# Improved Pro Series® Cylinders

## CYLINDER AND KEY ENHANCEMENTS

### NEW KEYS ROUND ON THE BOTTOM

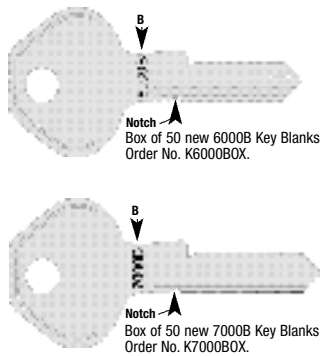
The keys affected are the 6000 and 7000. Rounded bottom keys stamped 6000B and 7000B have replaced them.

Avoid duplicating an old style key onto a new “B” style round-back blank. Cuts will be .0125" too deep. Use codes below to cut.

Cut	Root Depth
0	.2845"
1	.2690"
2	.2535"
3	.2380"
4	.2225"
5	.2070"
6	.1915"
7	.1760"

### OLD KEYS FLAT ON THE BOTTOM

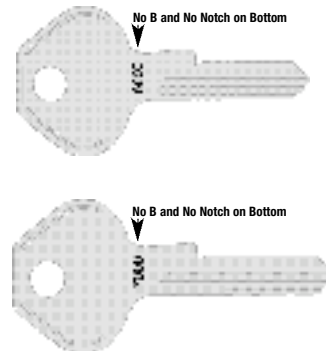
Avoid duplicating a “B” round-back key onto an old style blank. Cuts will be .0125" too shallow. Use codes below to cut.

Original blanks no longer available.

Cut	Root Depth
0	.271"
1	.256"
2	.240"
3	.225"
4	.209"
5	.194"
6	.178"
7	.163"
